**It still looks like a grocery store, but it isn't.**

Address: 400 West Simpson Street  
@ Samaniego Avenue,  
El Hoyo/Barrio Historico, Tucson, Arizona

Zoning Review Transmittal

PROJECT:  
T22CM06636  
400 W Simpson St – HR-2  
New ADU, Shade Structures, fence & Walls (1st Review)

Development Zone - S. Samaniego Ave Study - Proposed ADU Figure Ground & Street Elevation  
 400 W. Simpson - Elysian Grove Market  
 Scale 1:500

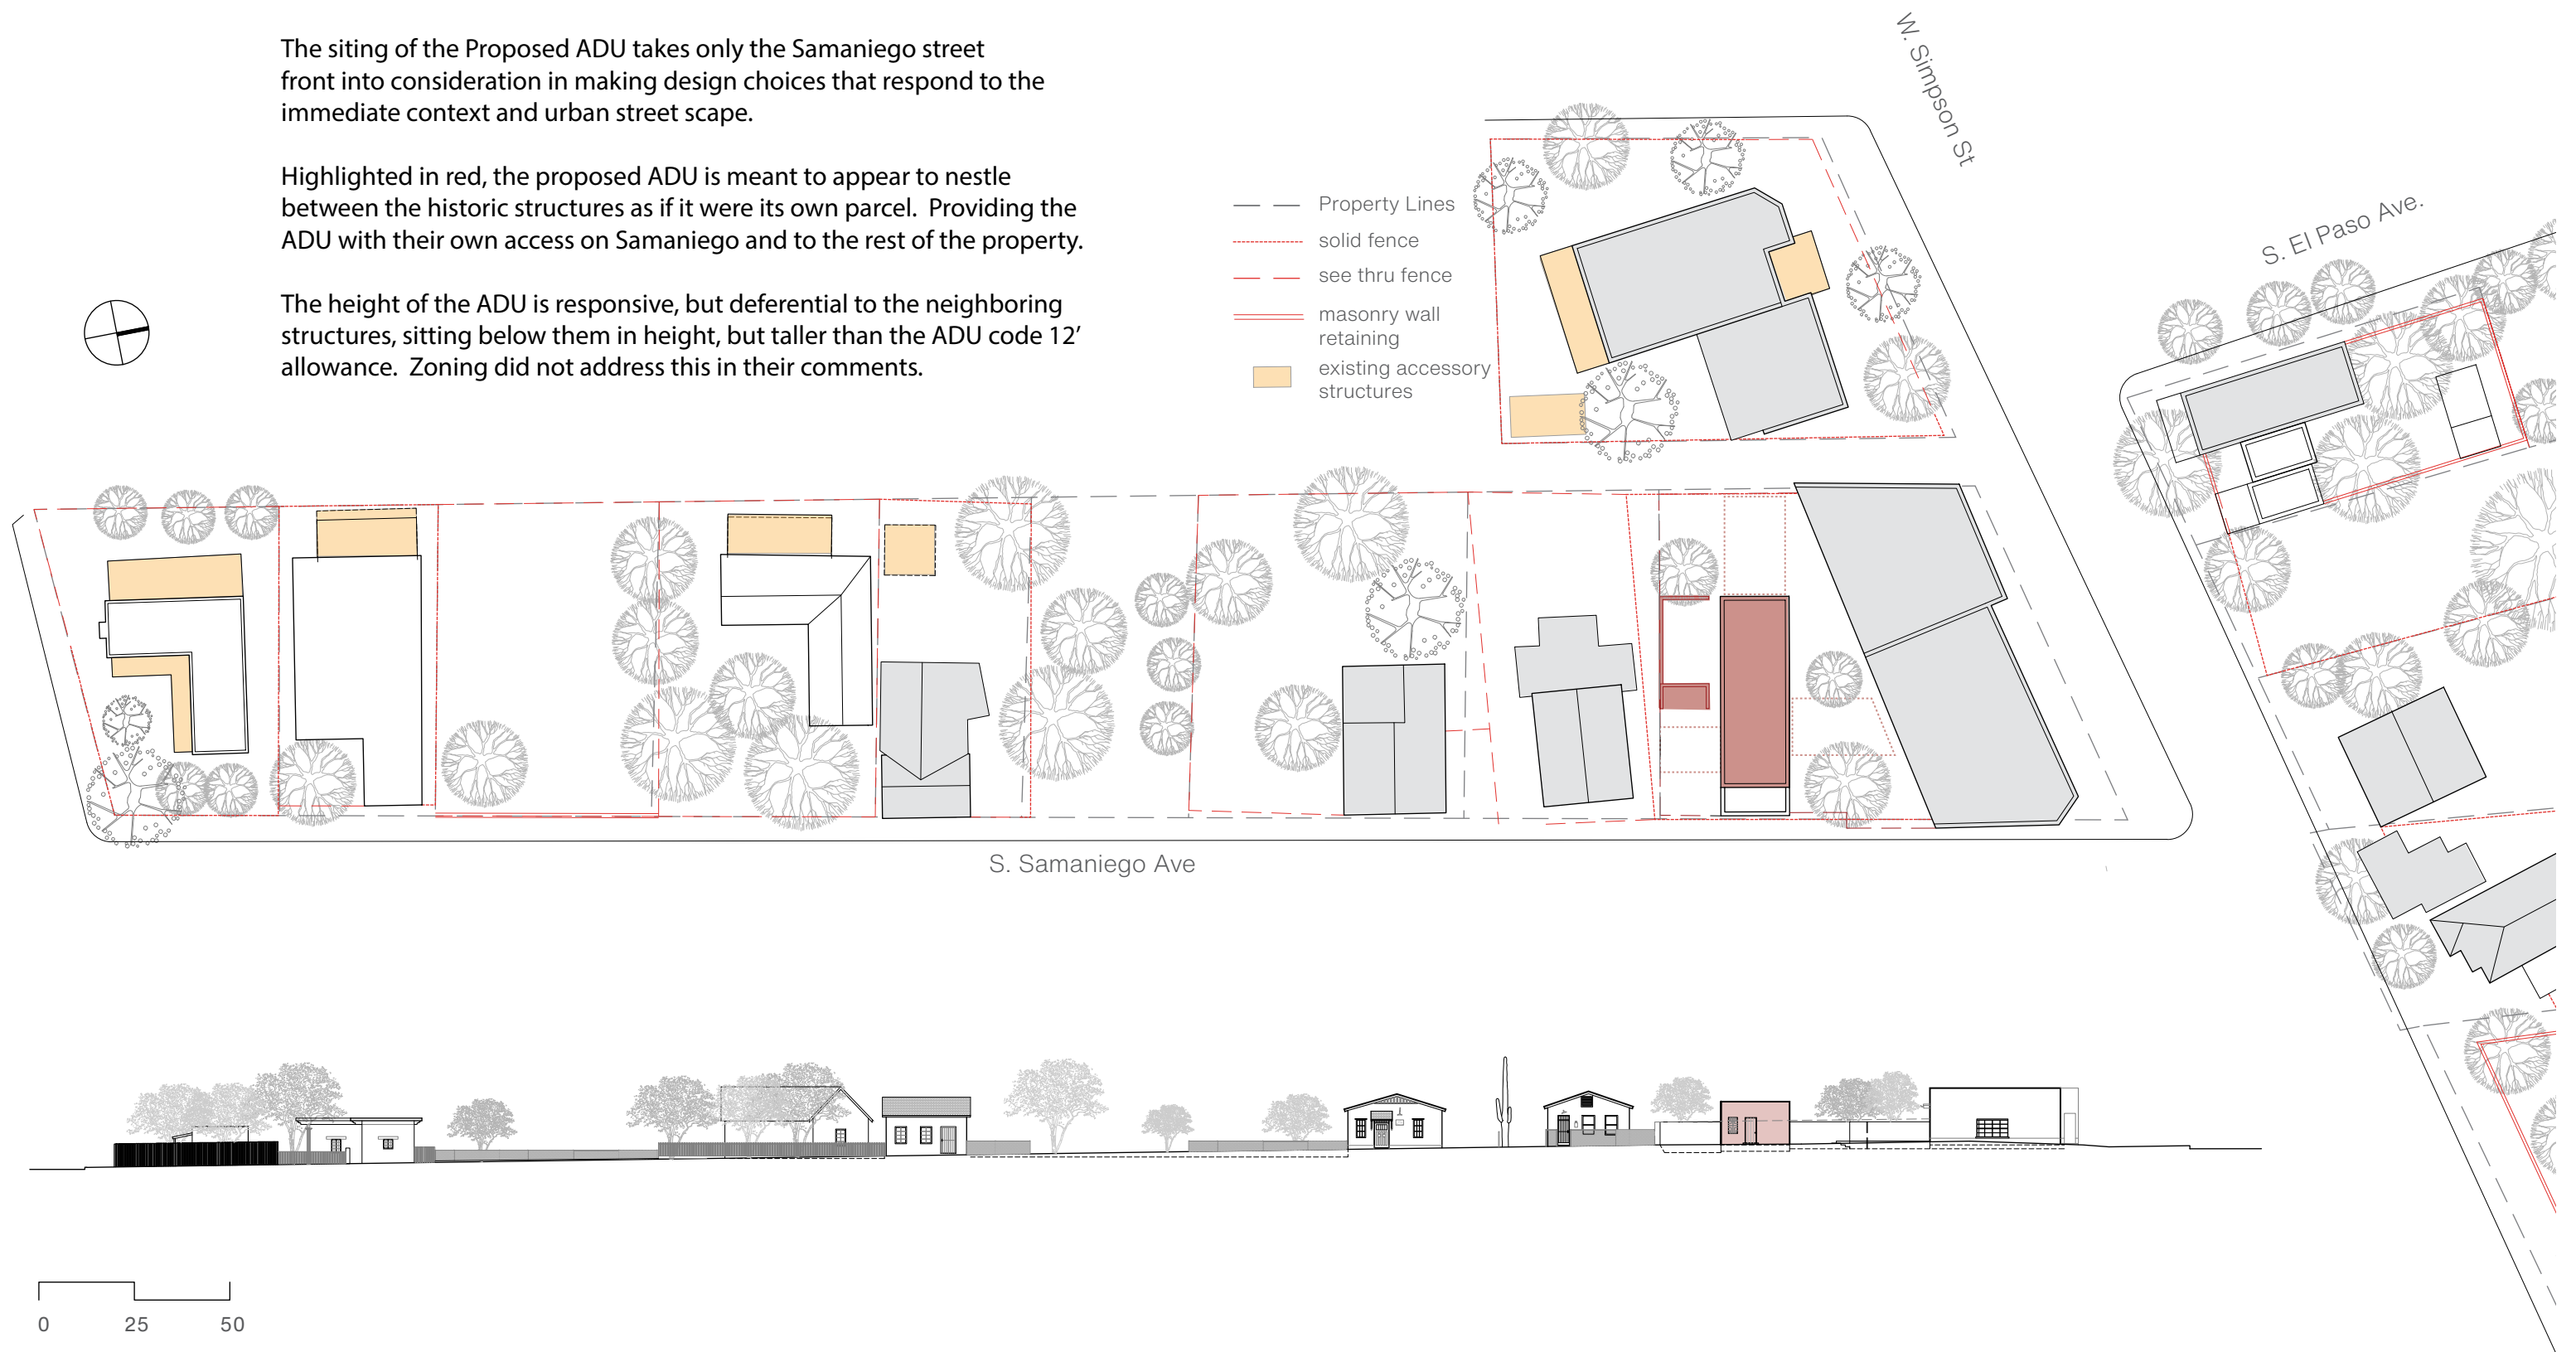
5. The minimum setback to a side street property line is ten (10) feet (UDC Section 6.4.5.C.1.b). Proposed side street setback from the proposed ADU is 0'-0"

The siting of the Proposed ADU takes only the Samaniego street front into consideration in making design choices that respond to the immediate context and urban street scape.

Highlighted in red, the proposed ADU is meant to appear to nestle between the historic structures as if it were its own parcel. Providing the ADU with their own access on Samaniego and to the rest of the property.

The height of the ADU is responsive, but deferential to the neighboring structures, sitting below them in height, but taller than the ADU code 12' allowance. Zoning did not address this in their comments.

Elysian Grove Site Plan - Lot Coverage Analysis  
 400 W. Simpson - Elysian Grove Market  
 Scale 1/16" = 1'-0"

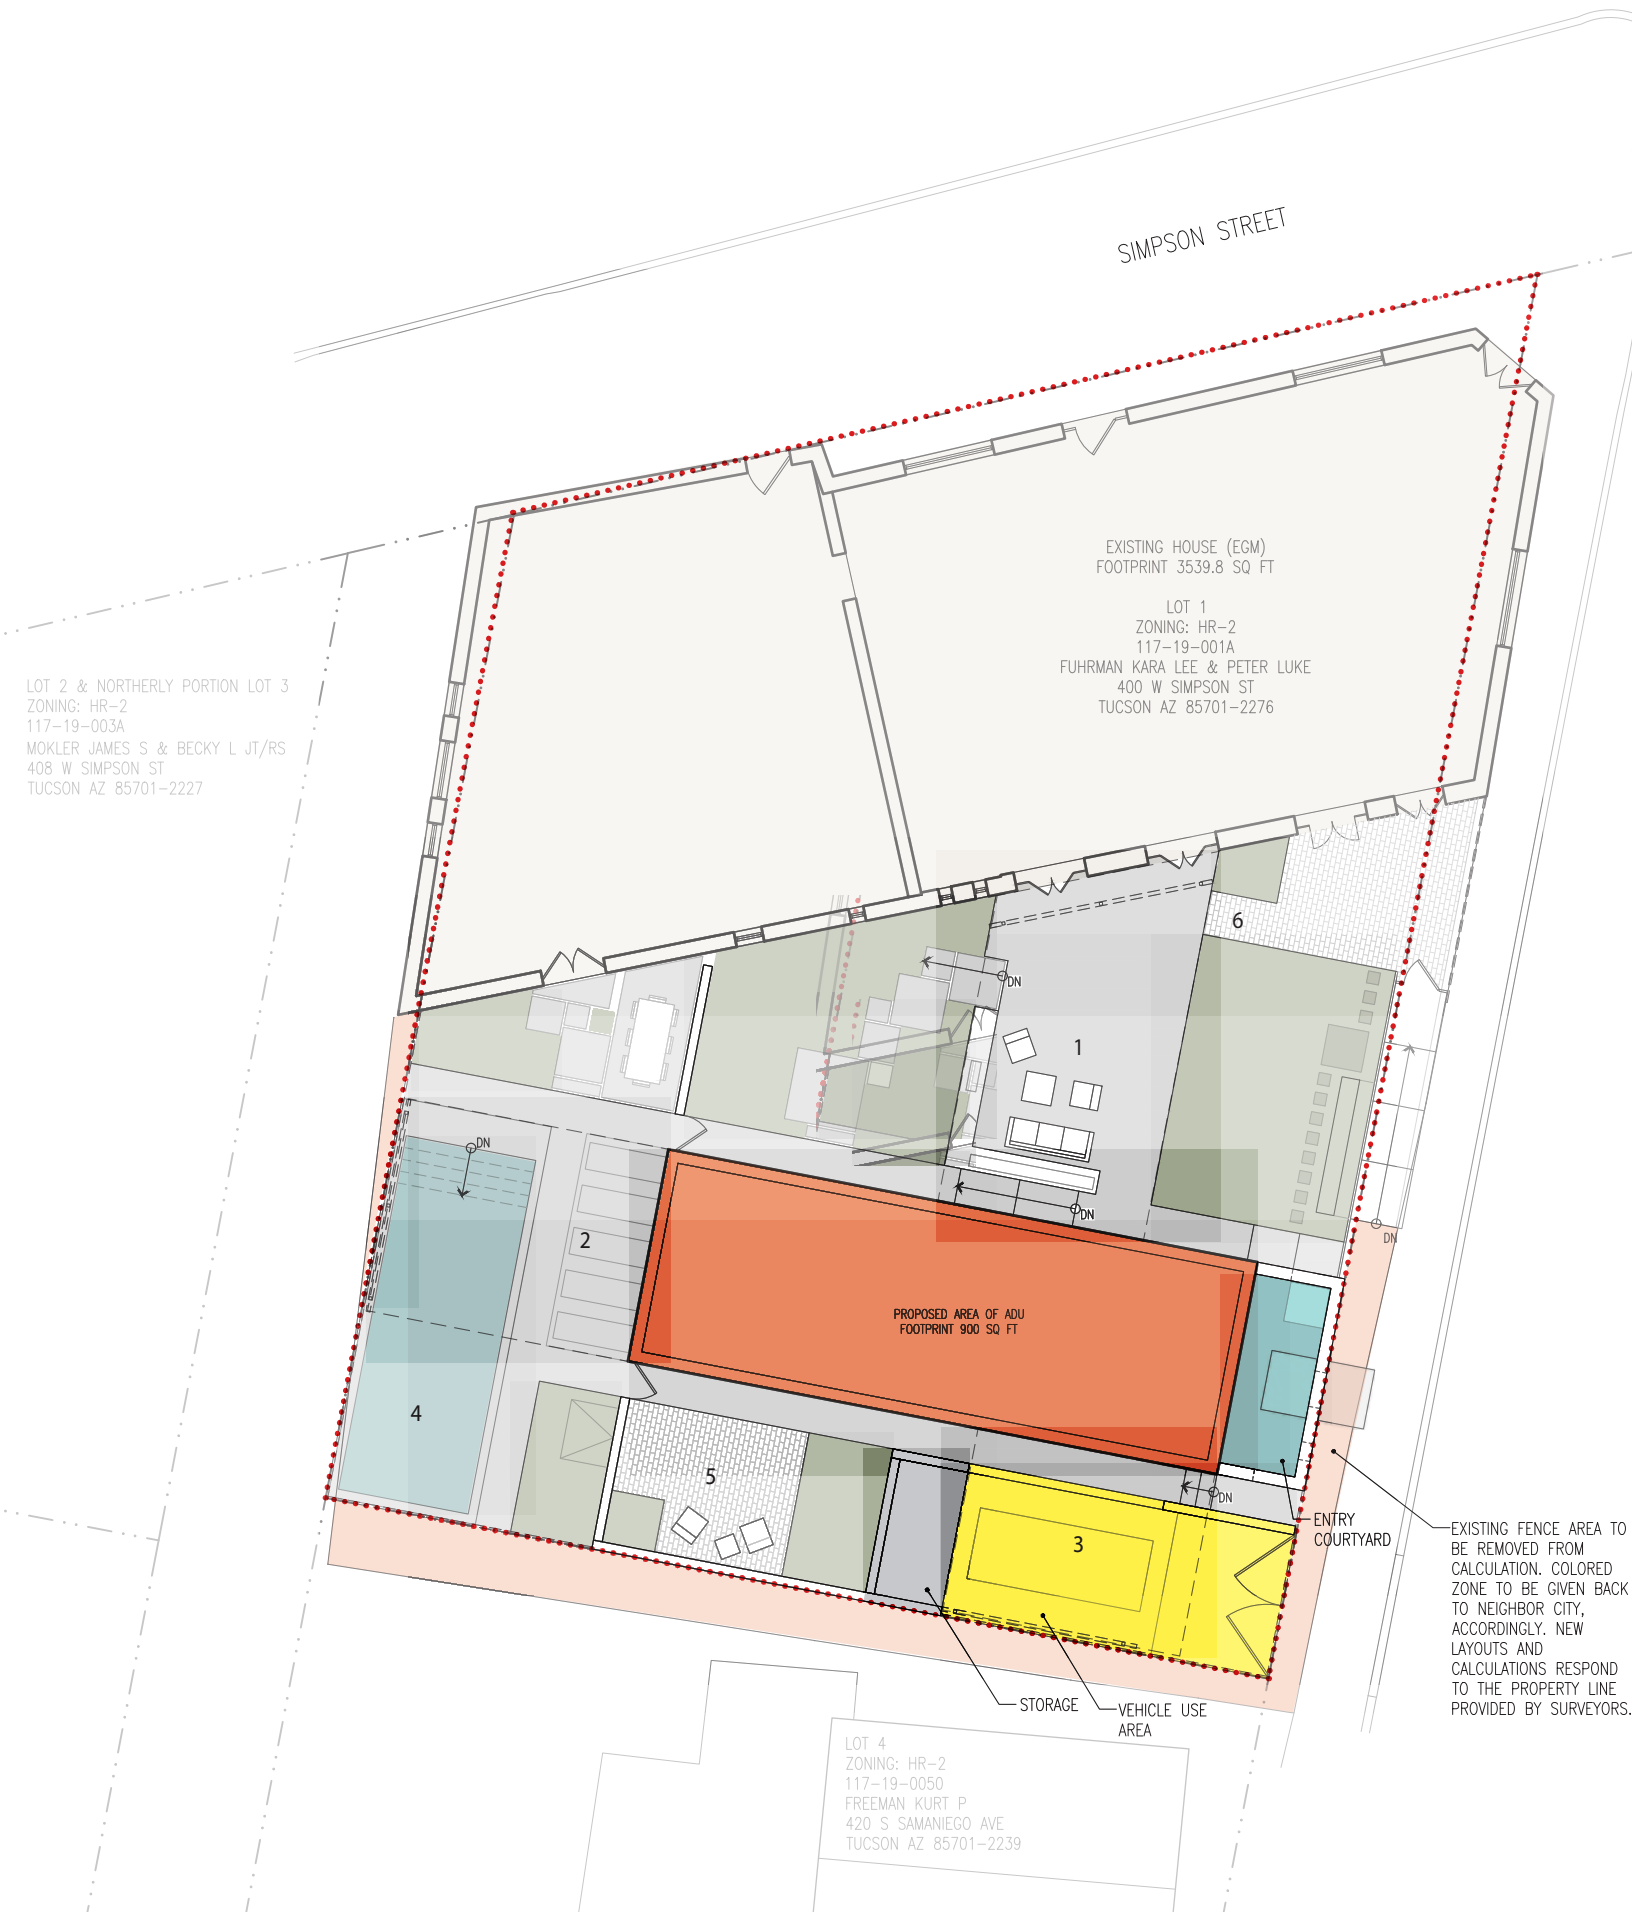
1. Based on a post height of 10'-0" the required perimeter yard setback from the post supporting the fabric shade system to the west property line is 6'-8", proposed setback is 0'-0".
2. Based on a post height of 9'-2" the required perimeter yard setback from the post supporting the fabric shade system attached to the ADU to the south property line is 6'-2", proposed setback is 0'-0".
3. Based on a wall height of 8'-0" the required perimeter yard setback from the proposed storage structure to the south property line is 6'-0", proposed setback is 0'-0".

4. As heights were not called out for the "MASONRY WALL" shown on the plan Zoning cannot determine if setbacks are an issue.

6. New site fencing and retaining was are proposed.

We are hoping through this presentation, that the BHHZAB sees the sensitivity in response to existing context and DZ and will find the comments left by Zoning and our design solutions acceptable.
